FISH PASSAGE CENTER

MEMORANDUM

Subject Comments on NMFS white paper entitled "Passage of Juvenile and Adult Salmonids at Columbia and Snake River Dams"

Figure 3. Relationship between survival and relative efficiency of Kaplan-type turbines for Columbia/Snake River projects [Data from Skalski et al. (2002, Table A.1)].

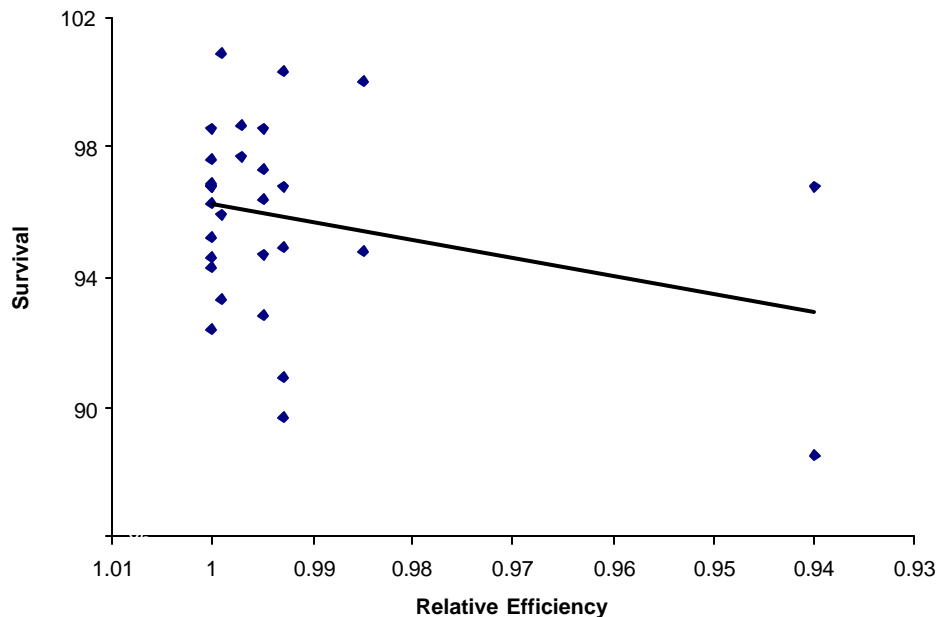
The data evaluated in Skalski et al. (2002) provide a second basis for maintaining the 1% efficiency limits. While their analysis was primarily focused on evaluating the academic question of whether peak survival coincides with peak efficiency, they do provide a useful summary of more recent data on the relevant operational question of maintaining the 1% of peak efficiency limits. Based on the data provided in Skalski et al. (2002, Table A.1), mean survival is reduced by 1.13% (for Columbia/Snake River projects) to 1.64% (for all projects) when Kaplan-type turbines are operated beyond the 1% of peak efficiency limits (Figures 1 and 2). In addition, survival decreases linearly as turbines are operated beyond peak efficiency for Columbia/Snake River projects (Figure 3).
